Technical Note

Project No: ITB12174
Project Title: Land west of Old Manor Farm, south of Lower Road, Bedhampton
Title: Further Highways Response
Ref: SJ/BC/RW/ITB12174-018A TN
Date: 23 June 2022

DRAWING No:	REV:
ITB12174-GA-018	F

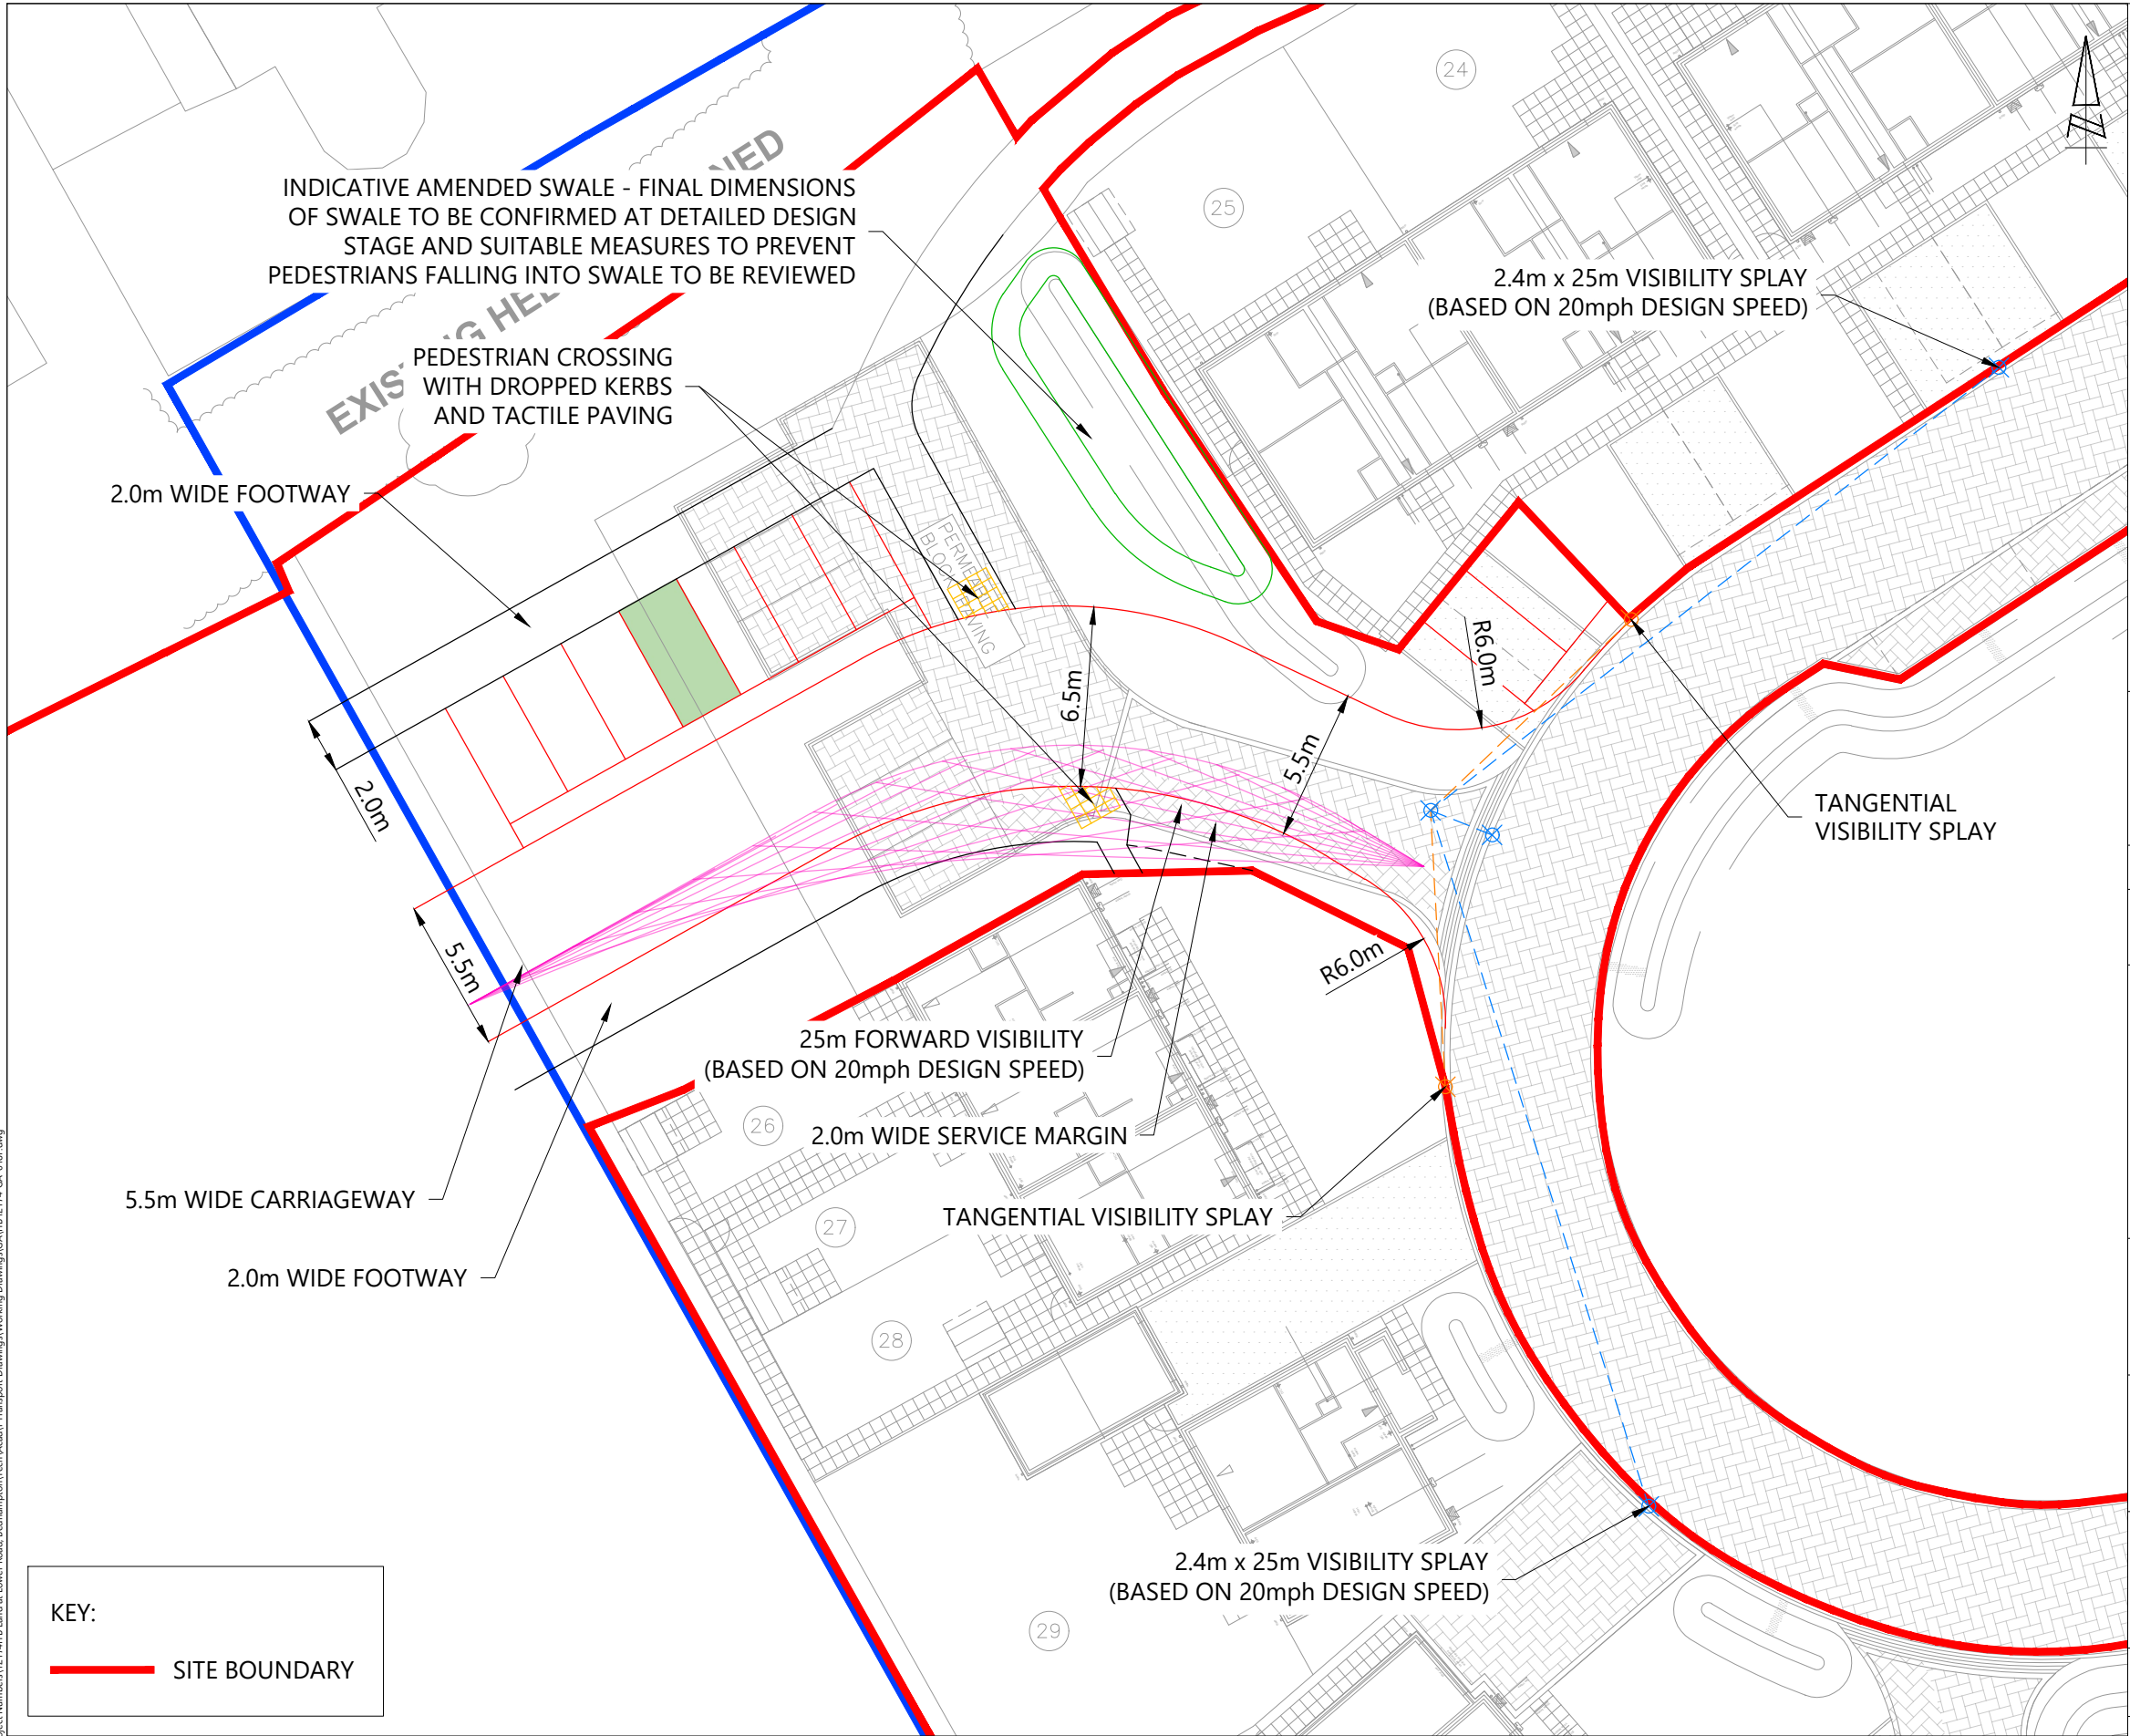
- 2.1.1 The swale within phase 1 conflicts with the proposed carriageway access connection into phase 2.

- 2.1.2 The swale has been redesigned, it has been made shorter to avoid the carriageway of the access road, whilst being widened to ensure the same (indeed greater) area of swale is retained. This amendment of widening the swale has required the relocation of north south section of footway located to the north of the access. This footway has been relocated west closer to the reoriented parking bays (for phase 1 plots 26-28) but with a suitable separation from them.
- 2.1.3 In addition, a 2m wide footway has been added to the southern side of the site access road (in place of the previously shown service margin) along with tactile paving to aid crossing between the relocated north south section of footway. These changes are shown on the revised site access **drawing ITB12174-GA-018 Rev F**.

- **Site access from phase 1.**
 - Updated drawing ITB12174-GA-018 Rev F shows an amended swale and walking provision.
- **Pedestrian trips from the approved Forty Acre Farm Development**
